# Addendum 3

Sugarcreek Water Treatment Plant and Wellfield Improvements

**Addendum No. 3**  
**May 27, 2022**

**P-34**

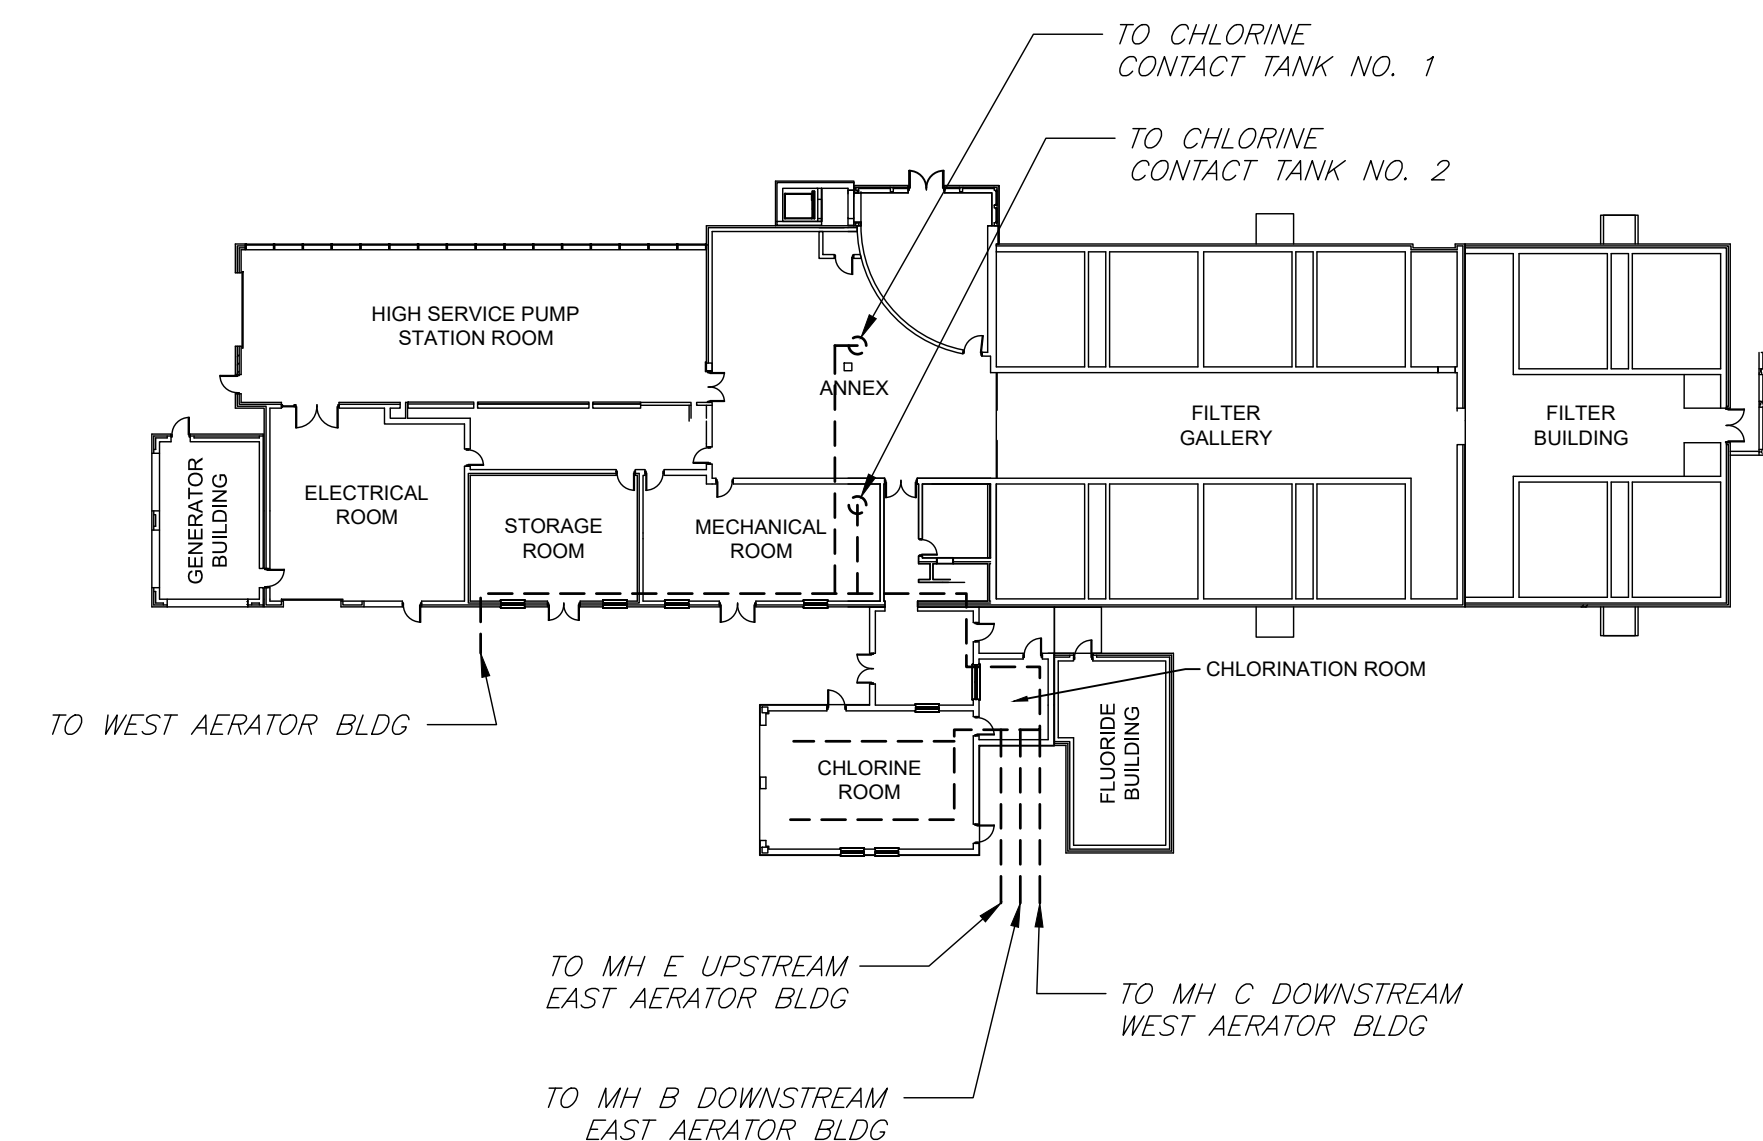
- In Section 21 and 23, at crane rail on column line 2A ADD arrow and symbol for Coded Note 2.
39. **Sheet P-34, Chlorine Building Process Schematics.** REPLACE with the attached P-34. Revisions were made the Chlorination Schematic. Piping from the chlorine cylinders to the evaporators has been revised.

**TRAFFIC-BEARING OIL SEPARATOR**  
WITH 50 CUBIC FEET EFFECTIVE CAPACITY

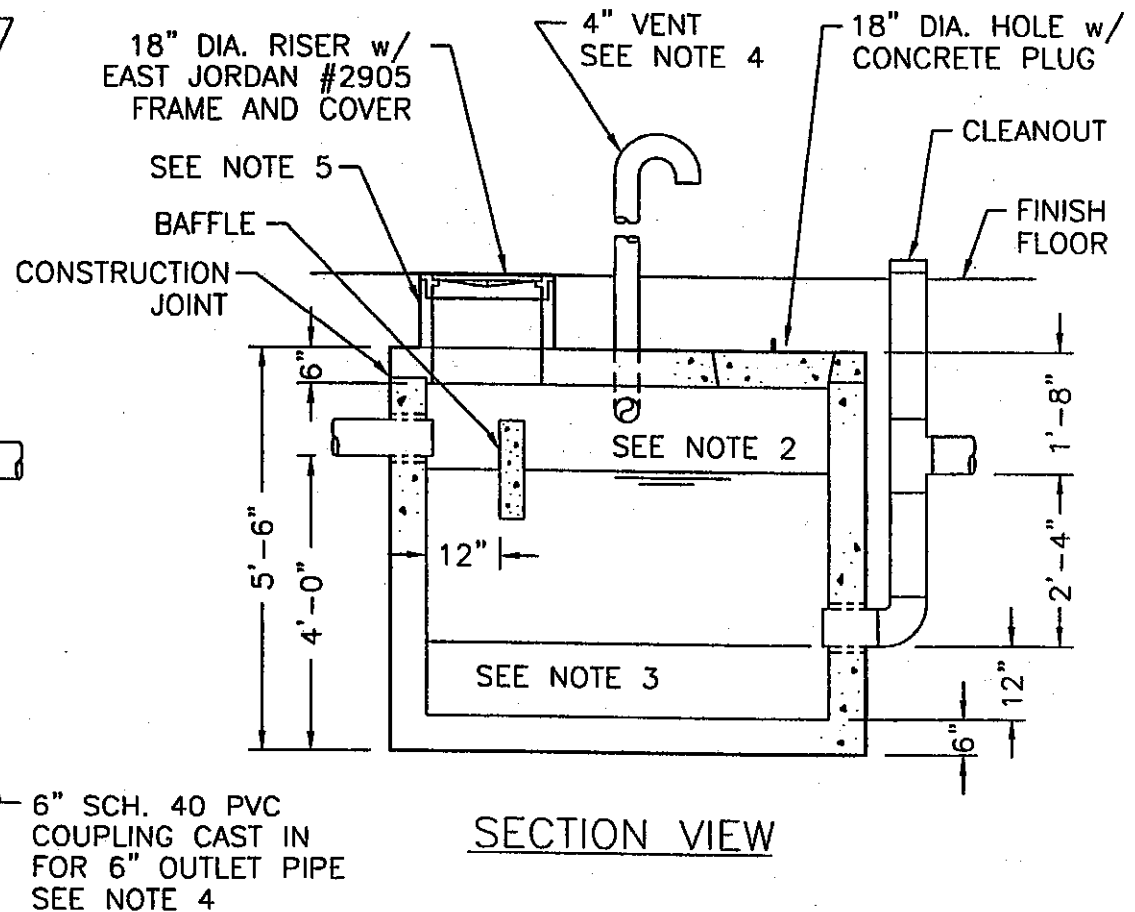
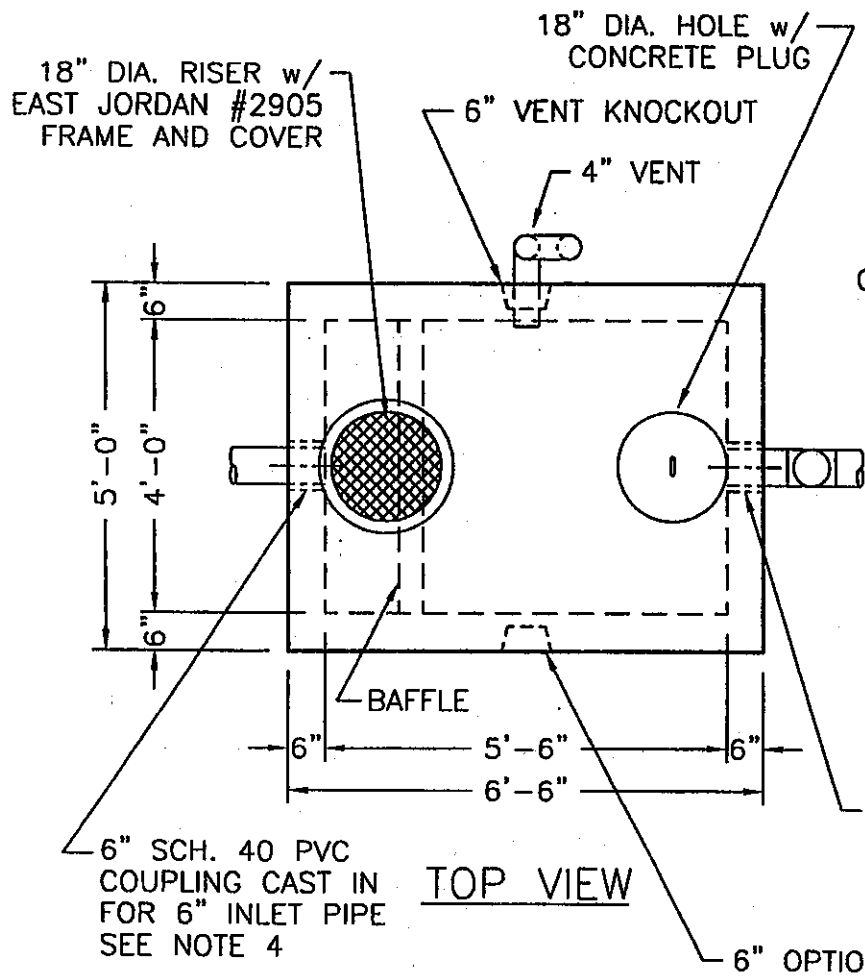
64. **Doghouse Manhole Detail.** Detail is on Sheet WC-26.
65. **Precast Oil Separator.** In the Maintenance Garage there is a precast concrete oil separator referenced on Page 48 of Section 01 14 00 – Work Restrictions Part 3.5 D. Paragraph 14. D. The oil separator is also called out on C-16. Additional information is included on Sheet PL-16 – Maintenance Garage Plumbing Plan. The precast concrete oil separator shall be Mack Industries Model E-10 (Catalog cutsheet is attached) which is a traffic bearing type oil separator or equal.
